**Re: Metal Bank Cottman Avenue NPL Site
Monthly Report due June 10, 2013
Reporting Period: May 1 through May 31, 2013**

Project Name: Metal Bank NPL Site	For the Month: May 2013	
Project Location: Philadelphia, PA	Report Number: 86	Dated: June 10, 2013

Re: Report
Sheet Pile Wall Inspection
Metal Bank NPL Site
7301 Milnor Street
Philadelphia, PA 19136

DETAIL 1

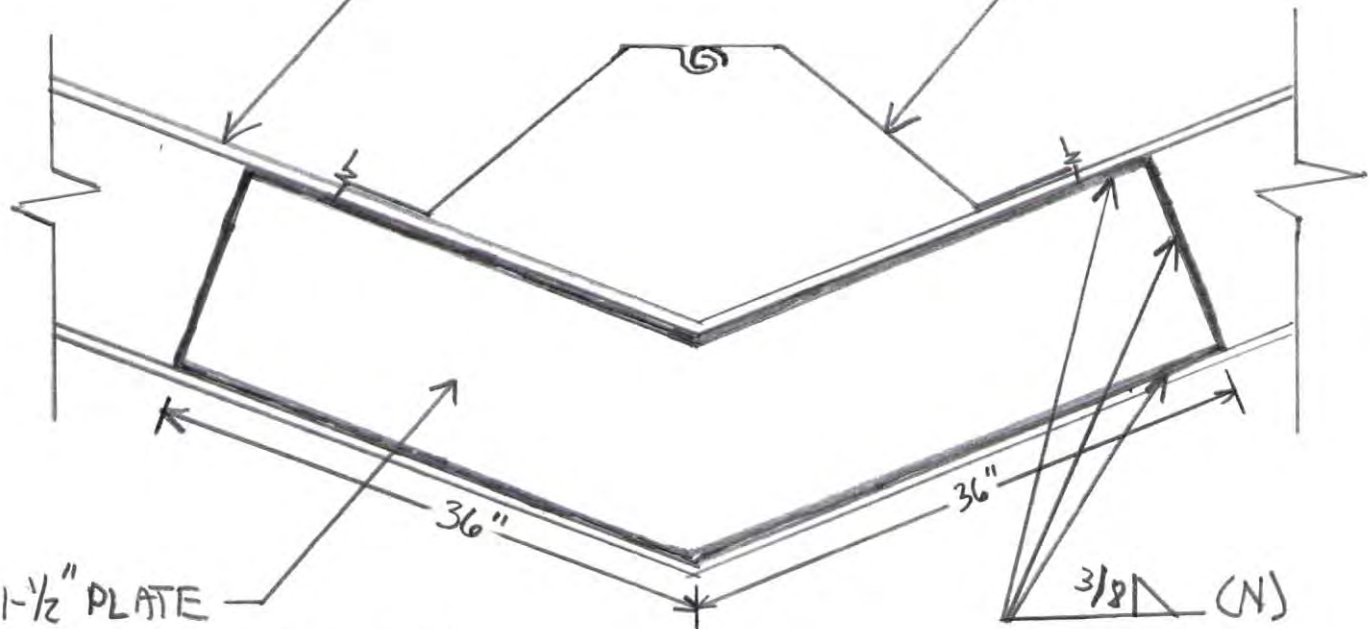
perpendicular to the plane of the sheetpile wall. Based on visual observations in other areas of the site, the sheetpile wall has moved (translated) laterally. This will tend to separate or “pull” the corner joint of the wale, resulting in cracks of the weld and steel. We recommend repairing the wale by:

- a. Remove epoxy coating and prepare wale to accept steel plate.
- b. Cut and install steel plate as shown on sketch presented in Appendix B.
- c. Areas adjacent to the corner that are cracked shall receive a steel plate placed within the upper wale flange and on top of the bottom wale web.
- d. Apply epoxy sealant in accordance with the original contract specifications.

(N) 1-1/2" PLATE
PLACE WITHIN FLANGE (TOP)
PLACE ON TOP WEB (BOT)
